**CAMECO RESOURCES
CROW BUTTE OPERATION**

Re: Annual Report of Changes, Tests, or Experiments
License No. SUA-1534
Docket No. 40-8943

2010 SERP Evaluation Index

Figure 5.1-1: Crow Butte Resources Organizational Chart

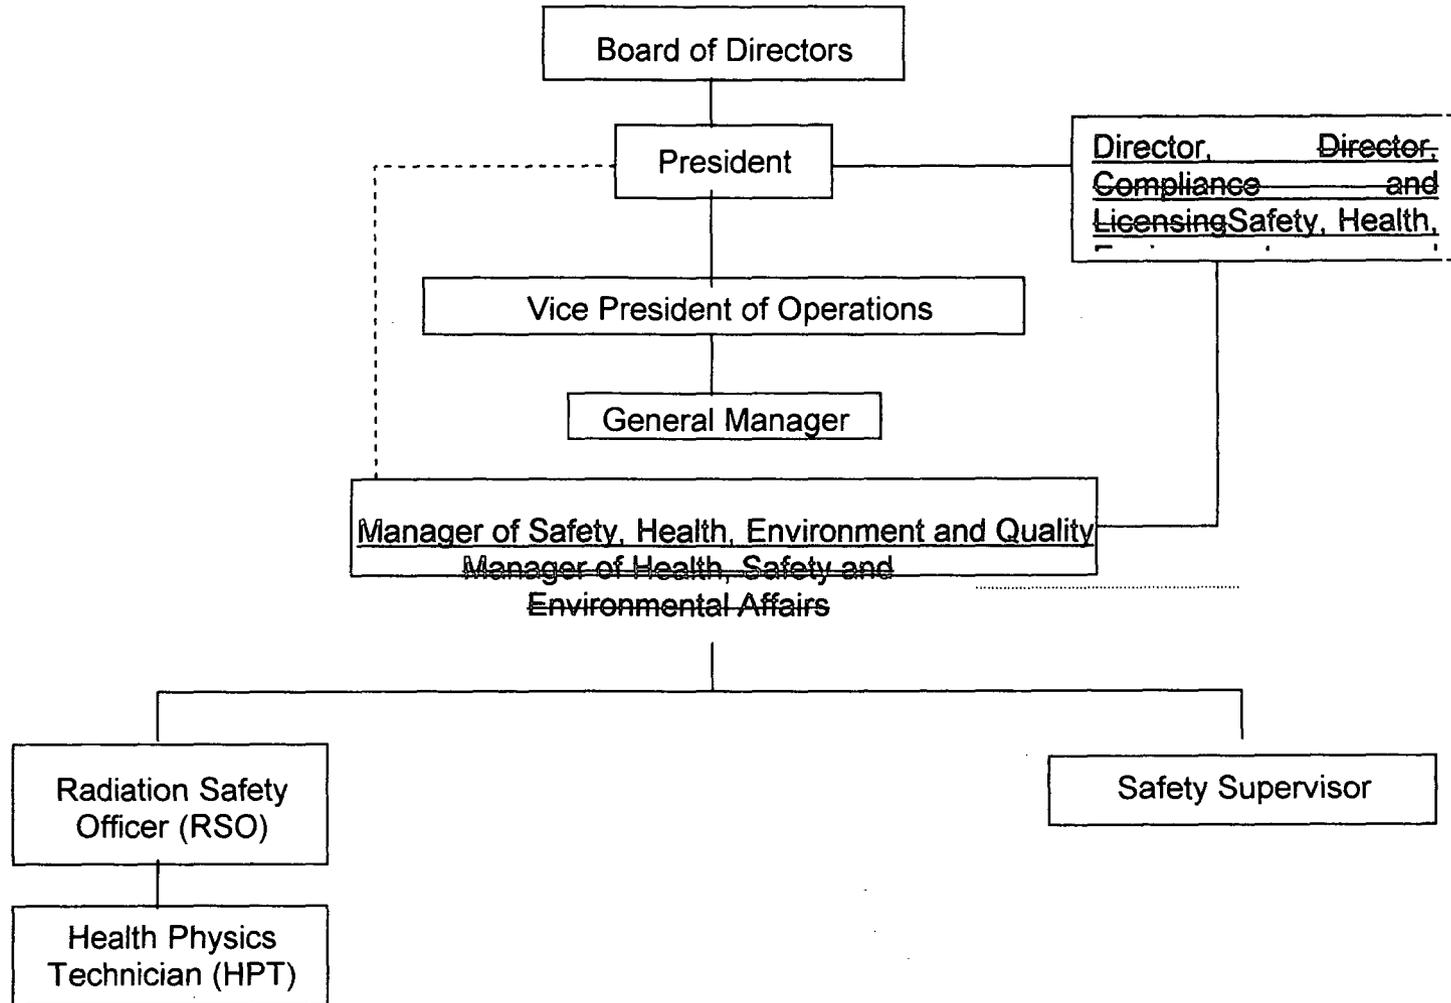
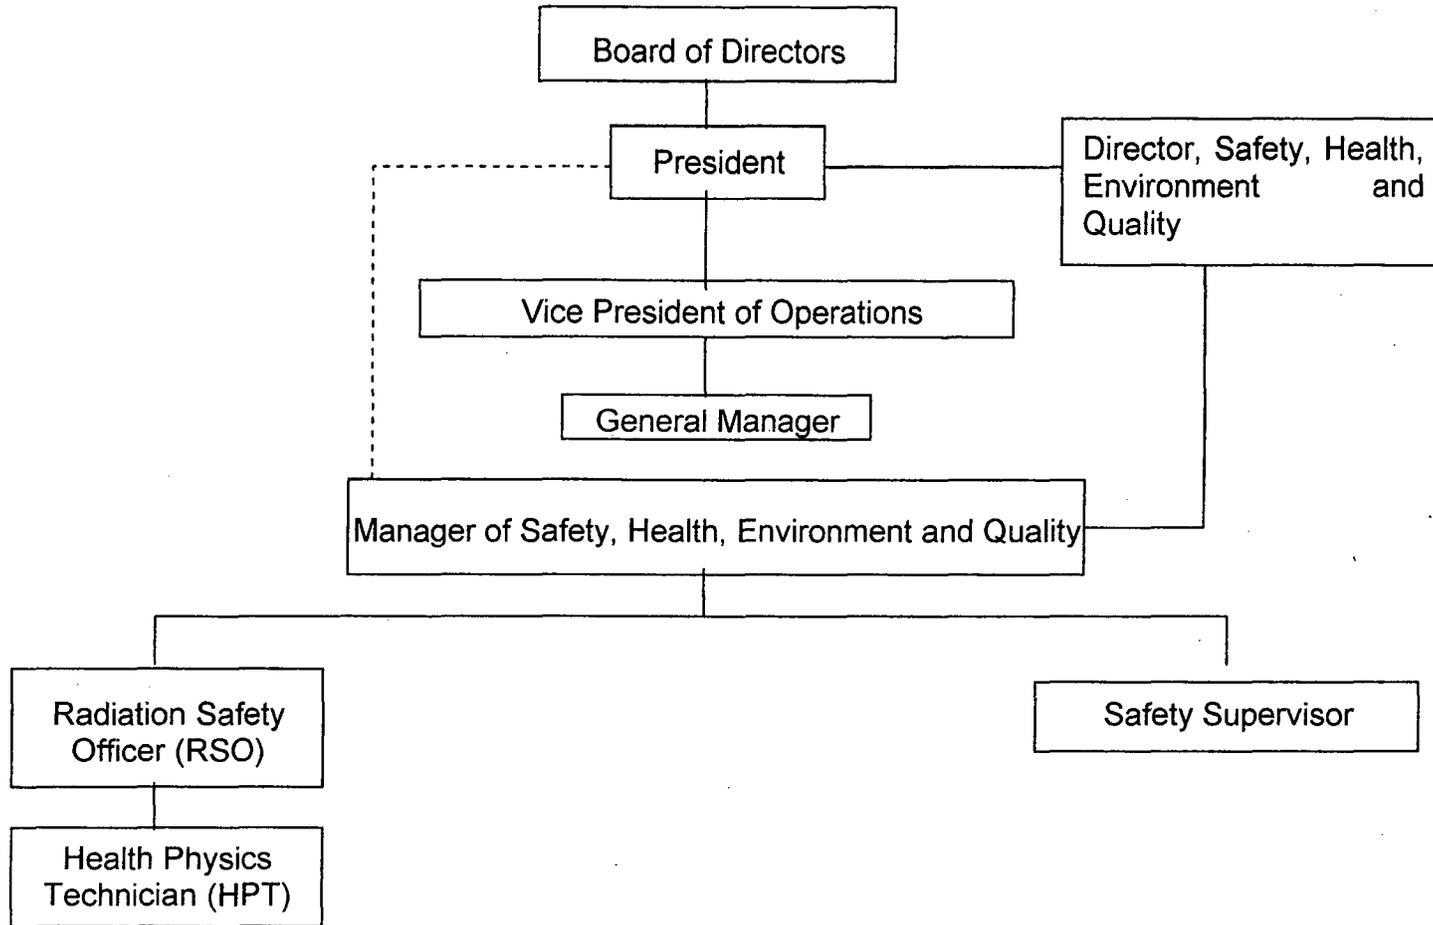
The purpose of the SERP evaluation was to review a change made to the corporate organizational structure. Specifically, to remove the position of Director, Compliance and Licensing, and add the position of Director, Safety, Health, Environment and Quality and to re-name the Manager of Safety, Health and Environmental Affairs position to Manager of Safety, Health, Environment and Quality.

An organizational change has been made that indirectly affects the reporting responsibilities of the radiation safety staff. The reporting for the Manager of Safety, Health, Environment and Quality has been changed as shown in the revised Figure 5.1-1 from the approved application. The SHEQ Manager now reports directly to the Director, Safety, Health, Environment and Quality who reports directly to the President. The new position of Director, Safety, Health, Environment and Quality has been added to the organizational structure. This position reports directly to the President and is responsible for ensuring the corporate personnel comply with industrial safety, radiation safety and environmental protection programs as stated in the EHS Management System. Since the RSO reports to the Manager of Safety, Health, Environment and Quality who in turn reports to the Director, Safety, Health, Environment and Quality, a change in the reporting for the Manager of Safety, Health, Environment and Quality and the removal of the Director, Compliance and Licensing position, will indirectly affect the radiation safety staff reporting.

The RSO is responsible for the development, administration, and enforcement of all radiation safety programs. The RSO is authorized to conduct inspections and to immediately order any change necessary to preclude or eliminate radiation safety hazards and/or maintain regulatory compliance. The RSO is responsible for the implementation of all on-site environmental programs, including emergency procedures. The RSO inspects facilities to verify compliance with all applicable requirements in the areas of radiological health and safety. The RSO works closely with all supervisory personnel to insure that established programs are maintained. The RSO is also responsible for the collection and interpretation of employee exposure related monitoring, including data from radiological safety. The RSO makes recommendations to improve any and all radiological safety related controls. The RSO has no production-related responsibilities. The RSO will report to the ~~Manager of Health, Safety, and Environmental Affairs~~Safety, Health, Environment and Quality.

The RSO is responsible for the development, administration, and enforcement of all radiation safety programs. The RSO is authorized to conduct inspections and to immediately order any change necessary to preclude or eliminate radiation safety hazards and/or maintain regulatory compliance. The RSO is responsible for the implementation of all on-site environmental programs, including emergency procedures. The RSO inspects facilities to verify compliance with all applicable requirements in the areas of radiological health and safety. The RSO works closely with all supervisory personnel to insure that established programs are maintained. The RSO is also responsible for the collection and interpretation of employee exposure related monitoring, including data from radiological safety. The RSO makes recommendations to improve any and all radiological safety related controls. The RSO has no production-related responsibilities. The RSO will report to the Manager of Safety, Health, Environment and Quality.

Figure 5.1-1: Crow Butte Resources Organizational Chart

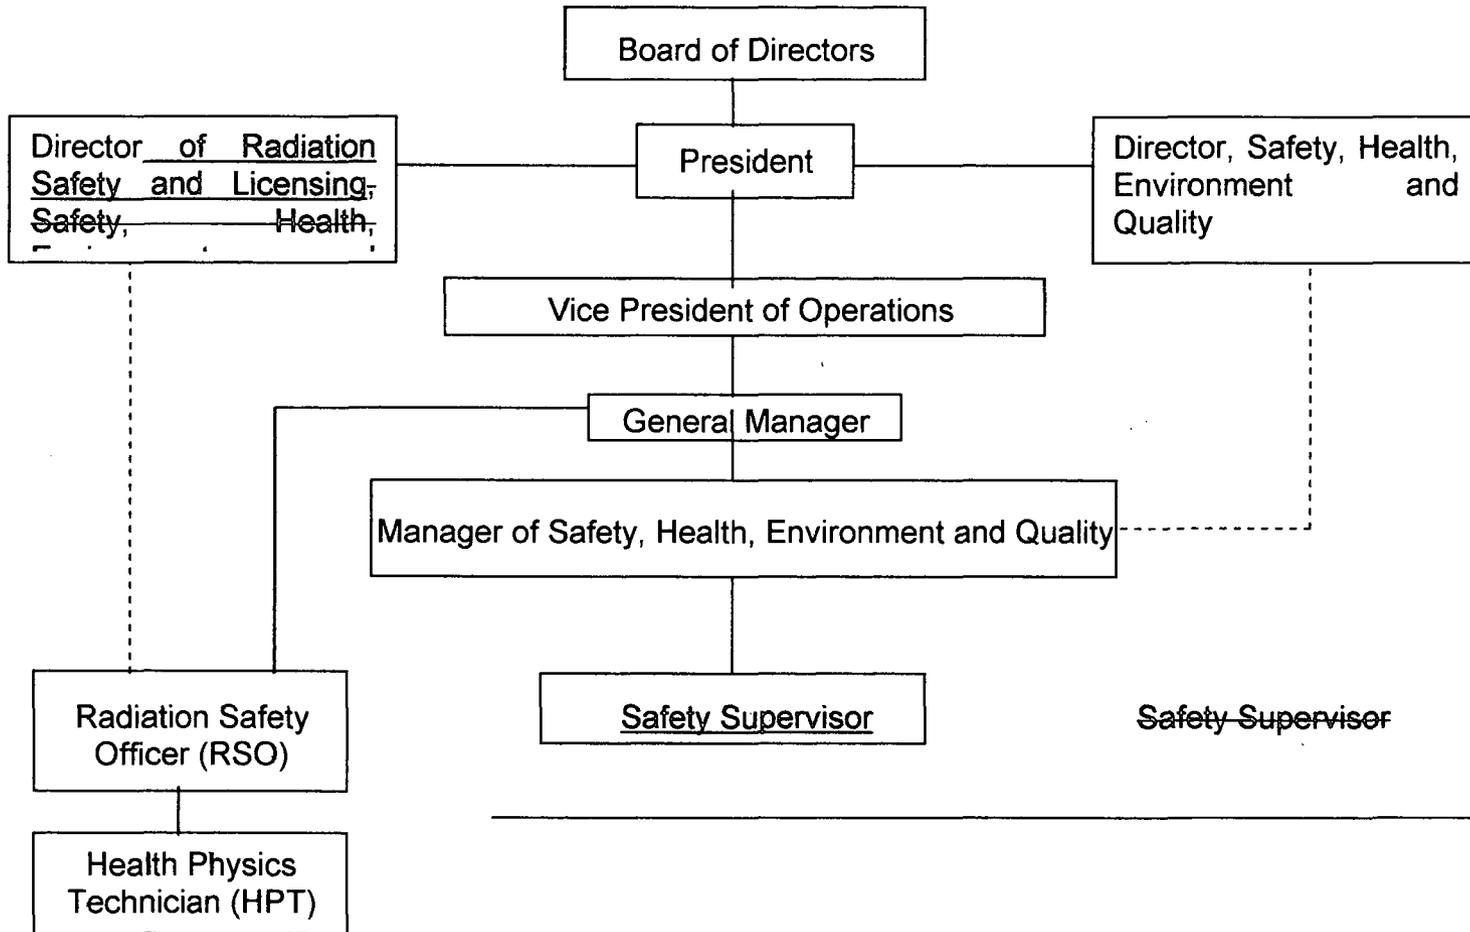
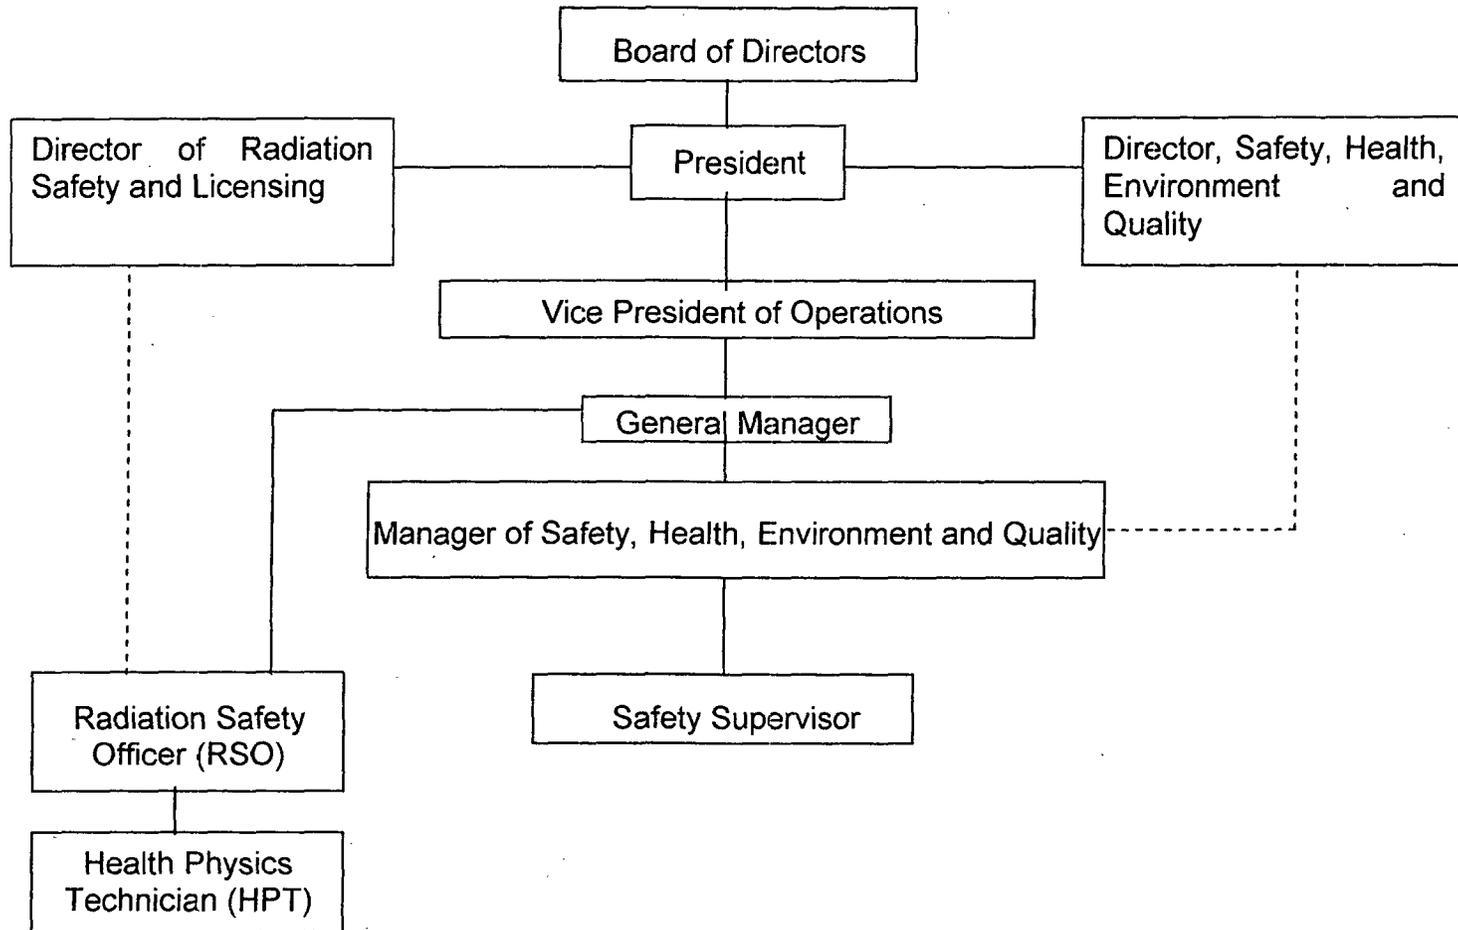
The purpose of the SERP evaluation was to review a change made to the corporate organizational structure. The evaluation adds the position of Director of Radiation Safety and Licensing and changes the reporting requirements for the Safety, Health, Environment, and Quality Manager and the Radiation Safety Officer.

An organizational change has been made that directly affects the reporting responsibilities of the radiation safety staff. The reporting for the Manager of Safety, Health, Environment and Quality (SHEQ) and Radiation Safety Officer (RSO) has been changed as shown in the revised Figure 5.1-1 from the approved application. The SHEQ Manager and RSO now report directly to the General Manager who reports directly to the Vice President. The new position of Director of Radiation Safety and Licensing has been added to the organizational structure. This position reports directly to the President and is responsible for submitting permit and license applications to appropriate regulatory agencies and will manage the approval process. This position will also act as a resource for the site SHEQ managers to ensure that permit conditions, agency responses, revisions, and, other Cameco SHEQ requirements are met. Since the RSO reports directly to the General Manager who in turn reports to the Vice President a change in the reporting for the RSO will directly affect the radiation safety staff reporting.

The RSO is responsible for the development, administration, and enforcement of all radiation safety programs. The RSO is authorized to conduct inspections and to immediately order any change necessary to preclude or eliminate radiation safety hazards and/or maintain regulatory compliance. The RSO is responsible for the implementation of all on-site environmental programs, including emergency procedures. The RSO inspects facilities to verify compliance with all applicable requirements in the areas of radiological health and safety. The RSO works closely with all supervisory personnel to insure that established programs are maintained. The RSO is also responsible for the collection and interpretation of employee exposure related monitoring, including data from radiological safety. The RSO makes recommendations to improve any and all radiological safety related controls. The RSO has no production-related responsibilities. The RSO will report to ~~the the~~ General Manager of Safety, Health, Environment and Quality.

The RSO is responsible for the development, administration, and enforcement of all radiation safety programs. The RSO is authorized to conduct inspections and to immediately order any change necessary to preclude or eliminate radiation safety hazards and/or maintain regulatory compliance. The RSO is responsible for the implementation of all on-site environmental programs, including emergency procedures. The RSO inspects facilities to verify compliance with all applicable requirements in the areas of radiological health and safety. The RSO works closely with all supervisory personnel to insure that established programs are maintained. The RSO is also responsible for the collection and interpretation of employee exposure related monitoring, including data from radiological safety. The RSO makes recommendations to improve any and all radiological safety related controls. The RSO has no production-related responsibilities. The RSO will report to the General Manager.
